Furniture & Shelving – Far Rockaway Community Library
Bid 1119-2
Questions and Answers
December 19, 2019

UTPSPEPU (B/W/G) (C/H/L)

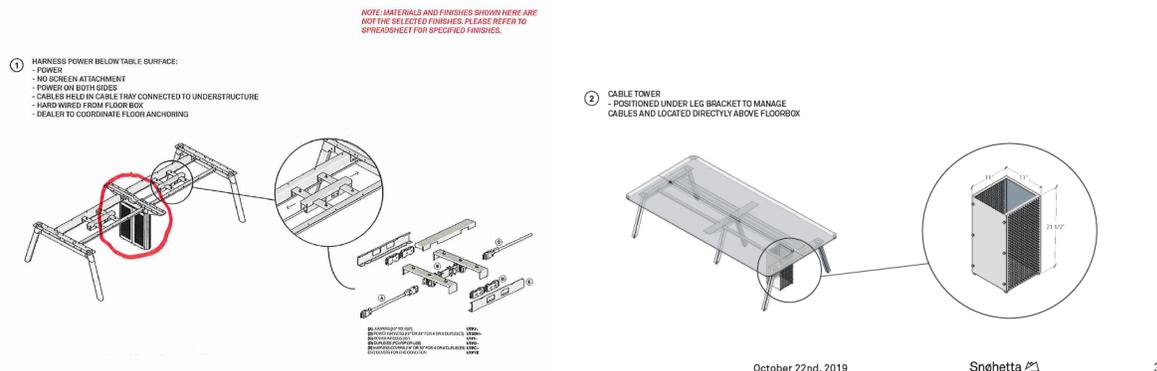
Q8. Your description for these tables is calling for (6) In Top Square Hardwired Power Modules (S6) (3.125” Square Grommet) for each table. These modules are individually hardwired. Your catalogue # UTST 1085428 B6 is calling for (6) B6 (2.5” Round Grommets). Please clarify which grommet you want specified. These size tables are standard with (3) grommets. Please confirm how many grommets you need per table. In addition, if you’re specifying the In Top Square Hardwired Power Modules you will need (6) core drills per table as per your specification.

A8. There Tables tagged T5-2, in the Adult Area Room 201, have three (3) square outlets (aka Power Modules) in each table. The revised table catalog number on the attached spreadsheet is UTST 1085428 S3. S designates the square power module and 3 is the quantity of power modules per table. The manufacturer’s code for the power module for table T5-2 is UTPSPPPU (B) (H). It contains (3) three prong plugs and 2 USB plugs per the image below.

The large table in the Quiet Room / Small Business Center Room 203, tagged T5-3, has four (4) square outlets (aka Power Modules) in the table. The revised table catalog number on the attached spreadsheet is UTST 1444828 S4. S designates the square power module and 4 is the quantity of power modules per table. The manufacturer’s code for the power module for table T5-2 is UTPSPEPU (B) (H). It contains (3) three prong plugs and 2 USB plugs per the image below.
